# ABINGTON TOWNSHIP

## PLANNING COMMISSION MEETING

- a. Review the Preliminary/Final Major Subdivision and Land Development for LD-23-03 - 1583 Rothley Avenue.

**RE: Executive Summary for LD-23-03-1583 Rothley Avenue**  
**PARID: 30-00-60076-00-5/ TMID: 30200 002**  
**PARID: 30-00-60072-00-9/ TMID: 30200 003**  
**Preliminary/Final Major Subdivision & Land Development Plans Review (2<sup>nd</sup> Submission)**

GRADING & UTILITY PLAN  
OF  
**1583 ROTHLEY AVENUE**  
PREPARED FOR  
**DOLSON, LLC**  
ABINGTON TOWNSHIP, MONTGOMERY COUNTY, PA.

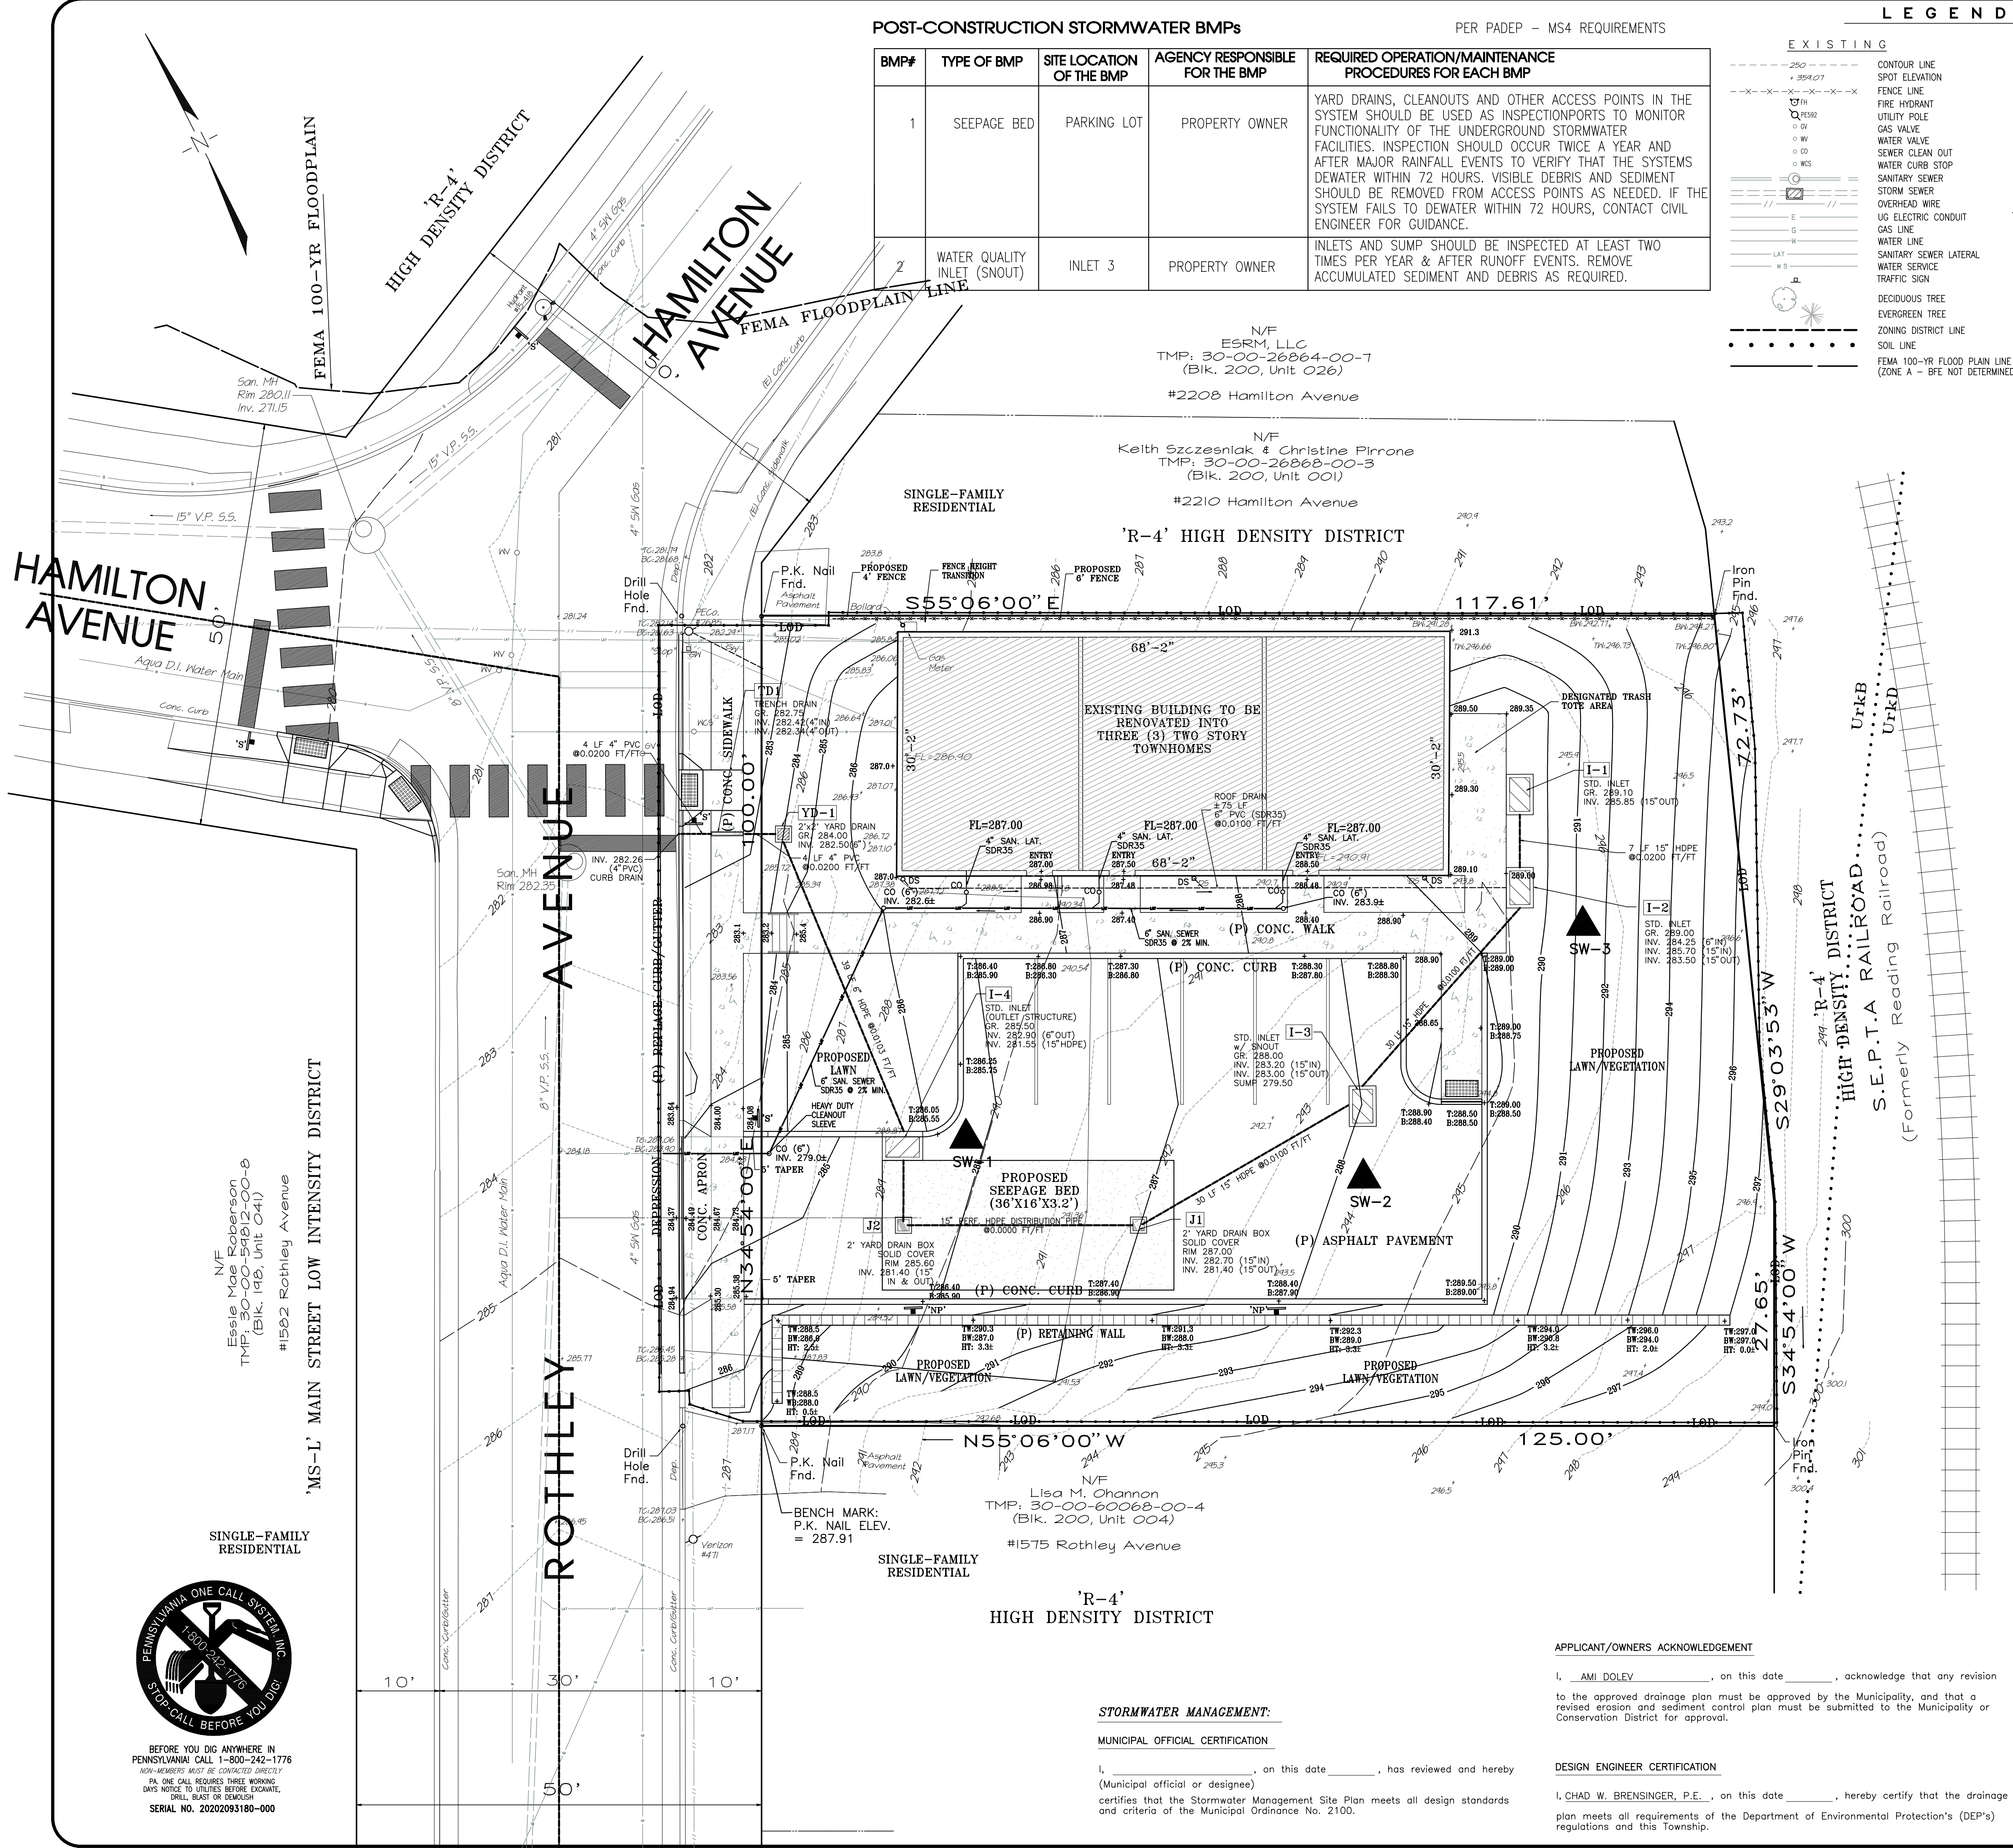
**The Applicant is proposing the retaining wall to be located in both the required front yard area and the required side yard area. On the Grading and Utilities Plan (Sheet 6), there are no top of wall and bottom of wall elevations provided. Based on the proposed grades, the wall will have an approximate height of 3 feet in the front yard area and an approximate height of 4 feet in the side yard area; however, the Applicant shall clarify and confirm the retaining wall heights and provide top of wall and bottom of wall elevations at regular intervals along the wall to ensure compliance with this accessory**
